Our Reference: 0178462_RESPONSE TO FURTHER INFORMATION REQUEST_APRIL2016.DOCX

RE: BIALA WIND FARM - REQUEST FOR FURTHER INFORMATION

I refer to the Department of Planning & Environment (DPE) request to Newtricity, as the Proponent of the Biala Wind Farm Project (SSD 13_6039), seeking further information relating to the environmental assessment of the Project as outlined in your email of 29 March 2016 and discussed at our meeting of 8 April 2016, and subsequent email requests of 31 May, and 2 and 10 June 2016 (copies attached in *Annex A*). Outlined below is our response to your queries and additional information as requested.

Figure 1 Daily Traffic Count, Crookwell Road 4/12/14

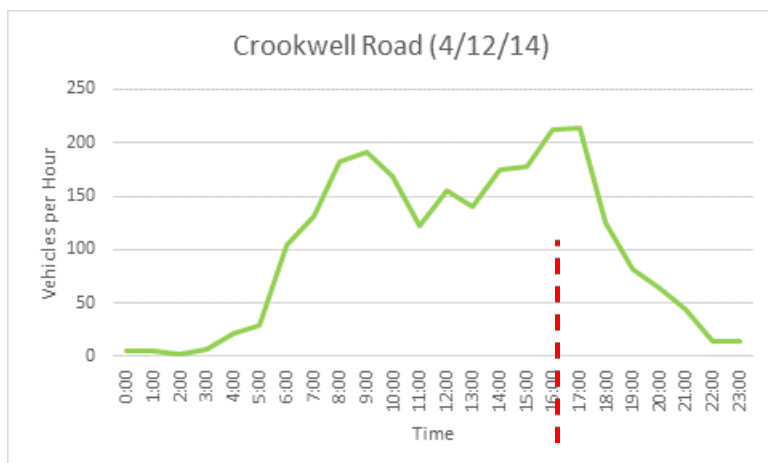
- 1) *Clarification of the existing traffic figures (daily and peak) along the key local roads. The traffic volume counts provided in Table 2.1 of the GTA Transport Impact Assessment (Annex K of the EIS) were taken during a short period of time (15 minutes) in the middle of the day. Please provide an analysis of the methodology used to extrapolate these figures for the peak hour and daily traffic estimates, and any additional local traffic data to confirm the accuracy of these traffic counts.*

The surveys of Crookwell Road indicated a peak hour traffic volume of 214 vph or 9% of the overall daily traffic volume of 2,387 vpd. The peak hour proportion of 9% is consistent with that identified for Grabben-Gullen Road (2013 Council counts). The surveys for Crookwell Road indicated a lunchtime (noon to 1:00pm) traffic volume of 156 vph or 6.5% of the overall traffic volume data.

This proportion (6.5%) was then applied to the sample counts collected for the surrounding roads to determine the estimated daily traffic volumes (refer *Table 1* below).

Figure 4.4: Road Network Spare Capacity

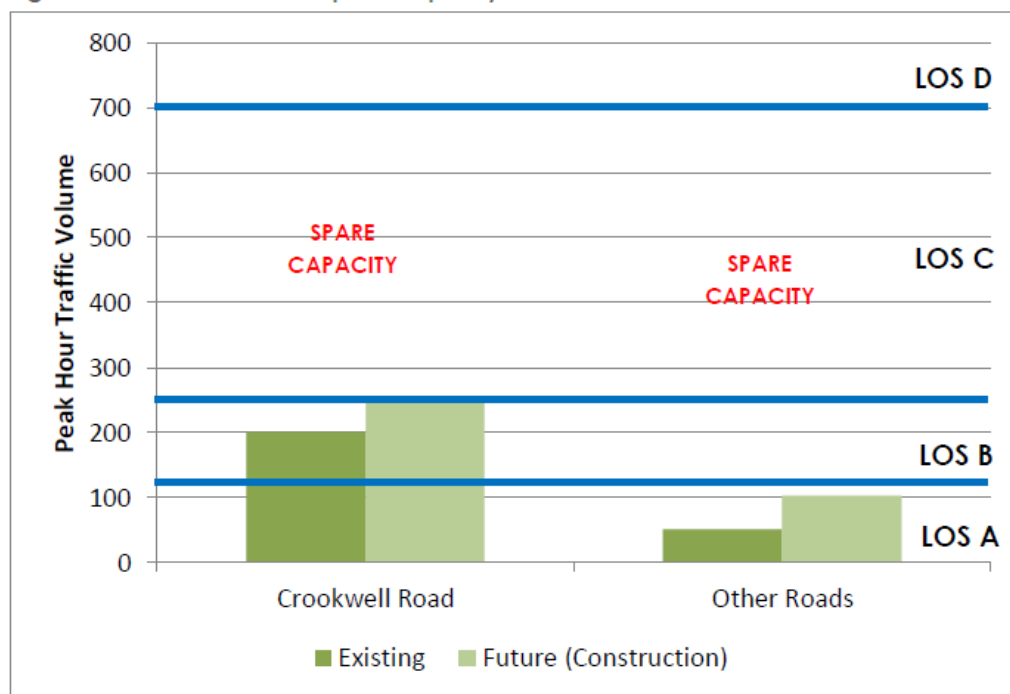
- 2) *Provision of the percentage increase in predicted traffic volumes associated with the Project when compared to the existing volume of traffic along key local roads (including a split between light and heavy vehicles); and*

In regards to Item 2 above, Figure 4.4 of the Transport Impact Assessment (GTA, 2015) is reproduced below, which illustrates the estimated increase in traffic

A breakdown of the estimated percentage increases in traffic volumes (including split between heavy and light vehicles) for the existing and future (construction) daily traffic volumes for the surrounding roads is presented below. The assessment assumes a worst case, with all traffic assumed to access the site via each of the roads assessed (consistent with the Transport Impact Assessment undertaken by GTA).

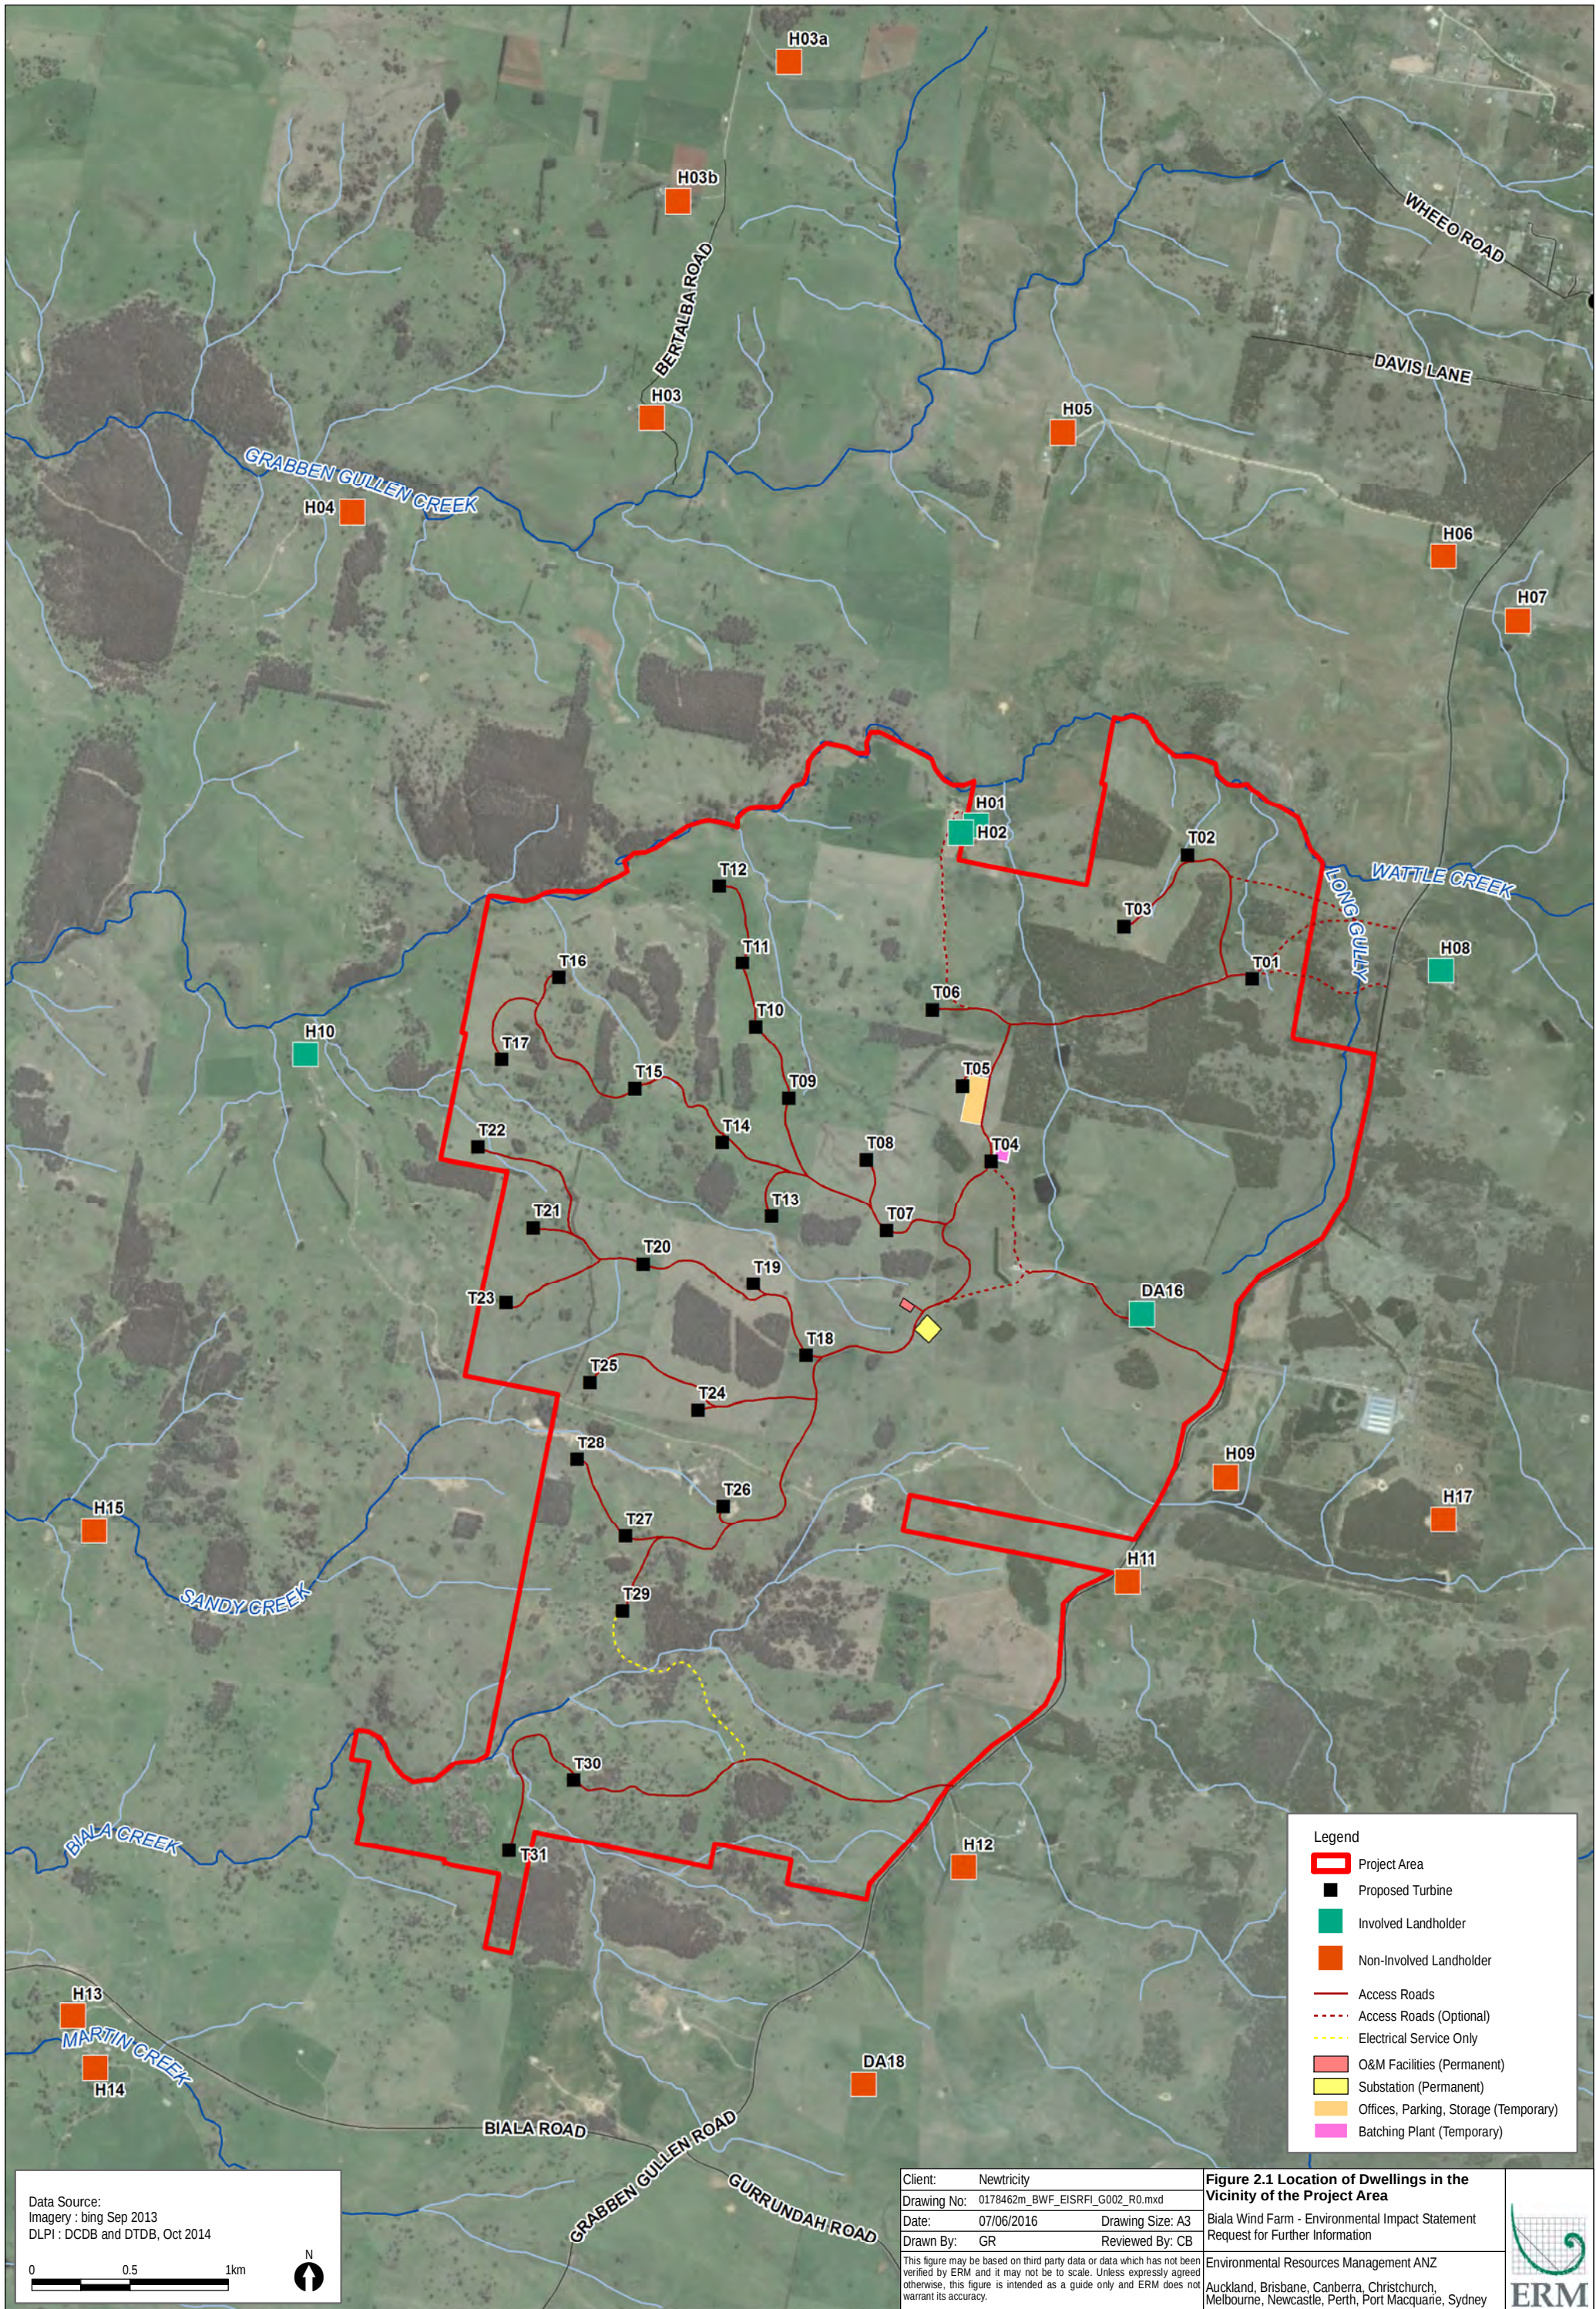
At the meeting of 8 April, DPE noted that the EIS and RtS Reports did not clearly demonstrate that two dwellings located along Church Lane / Bertalba Road had been considered and assessed for potential environmental impacts associated with the Project. DPE requested confirmation that these dwellings have been adequately assessed, specifically associated with potential visual, noise and shadow flicker impacts.

The two subject dwellings (referred to as H03a and H03b), are located north of dwelling H03. Dwelling H03 is located approximately 2,409 m from the nearest wind turbine generator (WTG), and dwellings H03a and H03b are located a further distance away as illustrated in *Figure 2.1*. Approximate coordinates of dwellings H03a and H03b are provided in *Table 3*.

The three dwellings located along Church Lane / Bertalba Road have been considered in the EIS and RtS, with any potential impacts to these dwellings identified.
